PRINCE HALL (DX-3-DE)

Nature of Project:
Construct rear addition;
remove front porch steps;
construct new front porch steps

APPLICATION FOR A CERTIFICATE OF APPROPRIATENESS – STAFF REPORT

COA-0142-2019 323 E CABARRUS STREET

PROPOSED ELEVATIONS

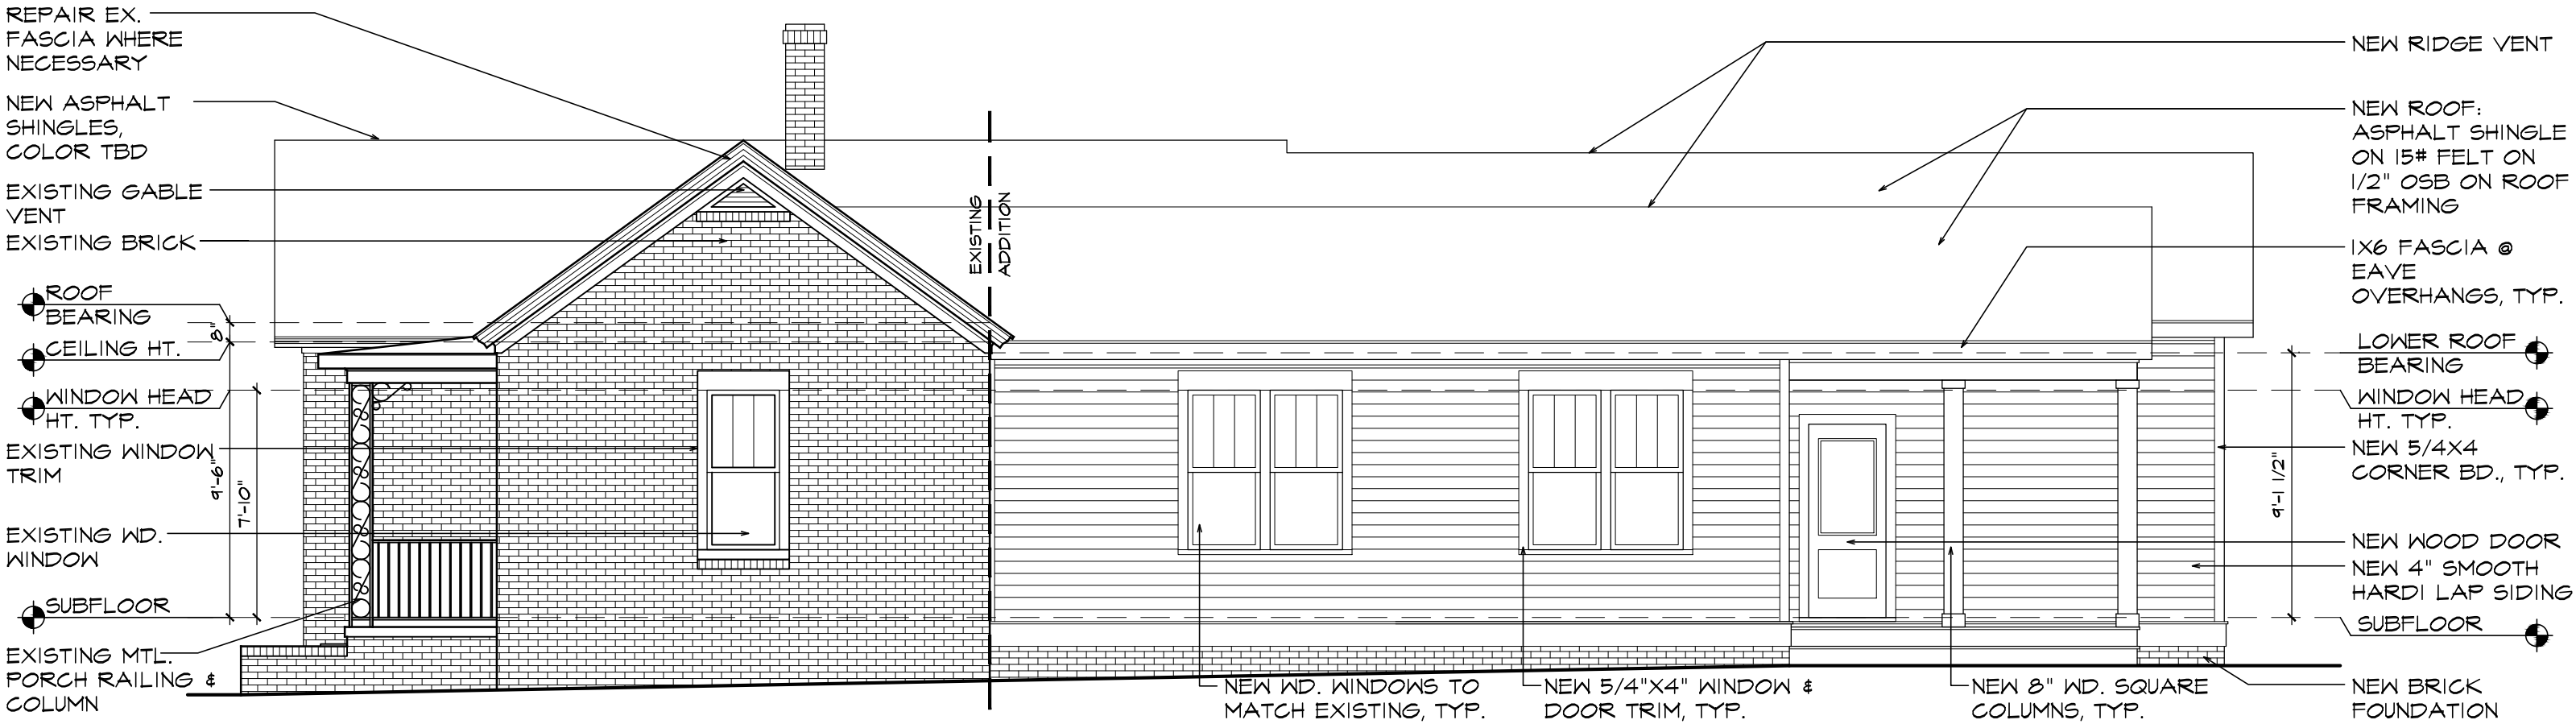
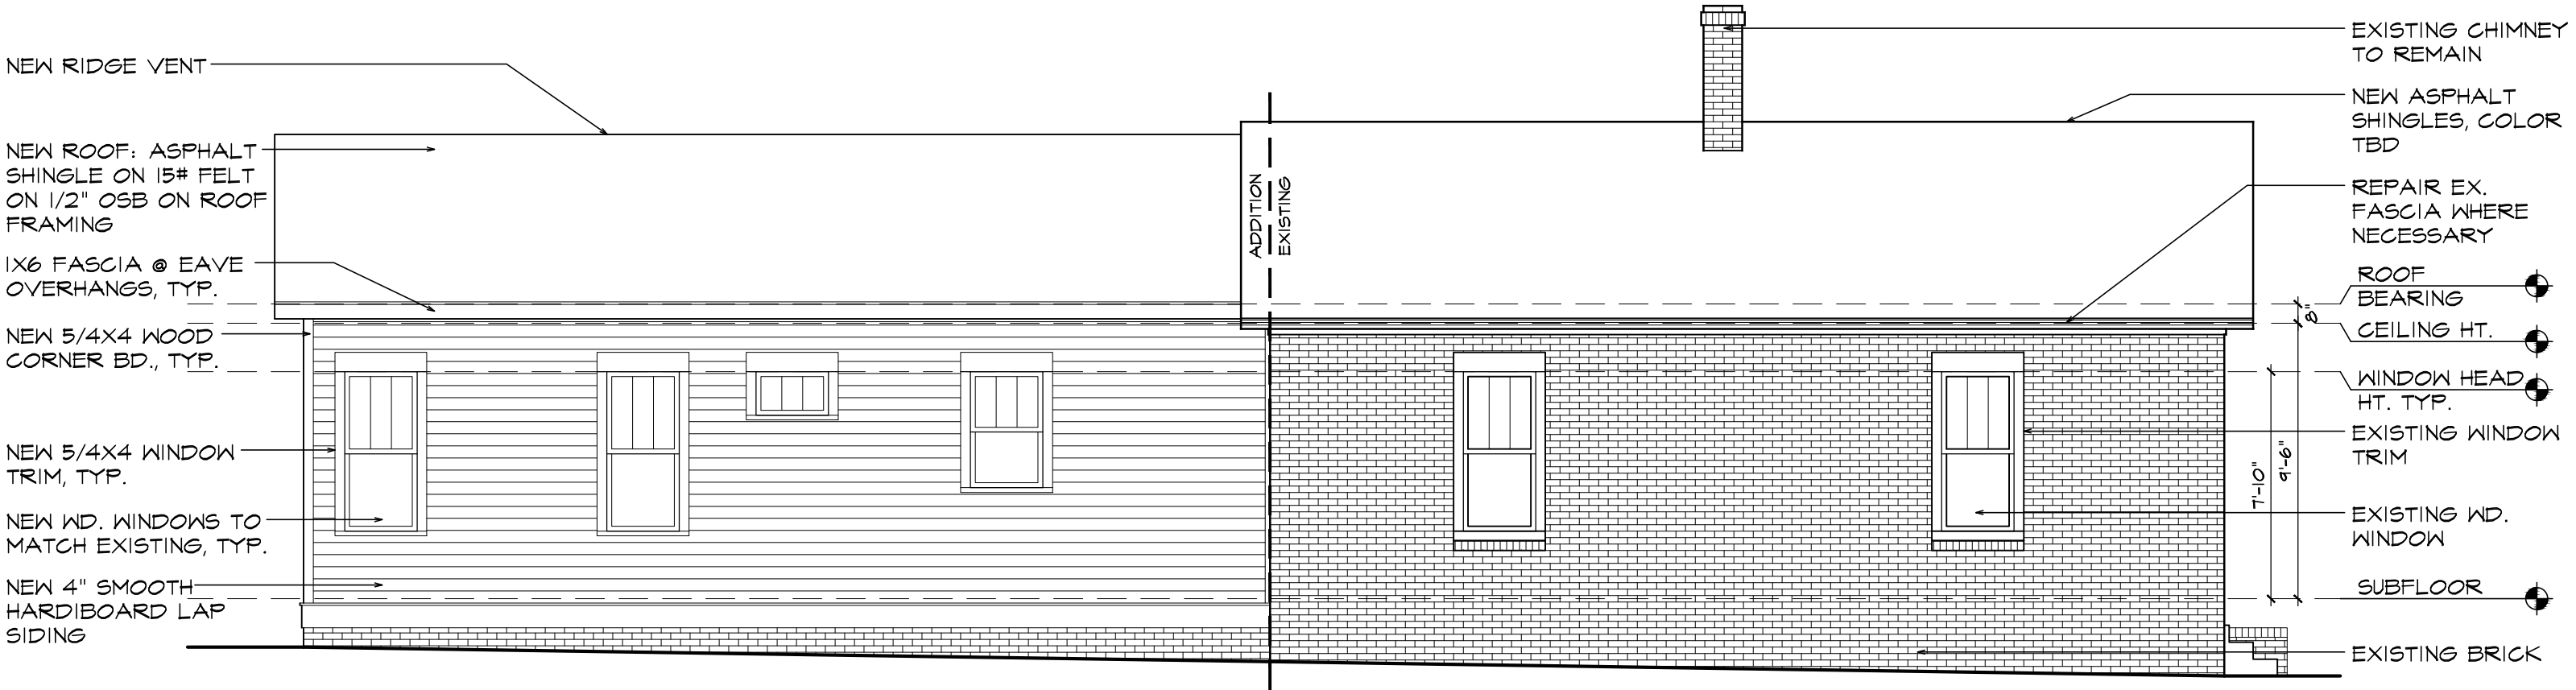
- 4* The proposed addition is a central gabled roof that matches the pitch of the existing roof coupled with a lower sloped shed roof on the east side of the addition.

- 5* On the east side, the new addition appears to double the length of the house.
- 6* On the west side, due to the change in material, the new addition appears to triple the length the house.

- 7* The proposed addition will be inset 19” from the left/west side of the house to delineate differentiation from the historic house. The right/east side of the addition is proposed in the same plane of the existing rear addition, which is set 9’ from the eastern-most wall of the historic house.

- 10* The application notes that the overhang soffits will be fiber cement. Eave details were not provided.
- 11* The application did not note that the fiber cement siding will be installed with the smooth side out, as has found to be congruous on previously approved rear additions to historic structures.

- 12* The foundation of the proposed addition is composed of solid brick that will match the existing brick veneer foundation in appearance.
- 13* The roof of the addition is proposed to be asphalt shingles. The application also includes the re-roofing of the historic house. The written description states that the color will match existing, while the drawings note that the color is to be determined.

- 20* Specifications were provided for the new wood door located on rear covered porch.
- 21* The written description notes that gutters and downspouts are proposed to match existing. Locations were not noted on the included drawings.

1. That all fiber cement elements on the addition be installed smooth side out.
2. That details and specifications for the following be provided to and approved by staff prior to the issuance of the blue placard:
 - a. Eave details.
 - b. A revised tree protection plan noting material storage and construction access.
3. That details and specifications for the following be provided to and approved by staff prior to the installation or construction:
 - a. Manufacturer’s specifications for paint;
 - b. Locations of gutters and downspouts;
 - c. HVAC location and screening;
 - d. Exterior lighting.
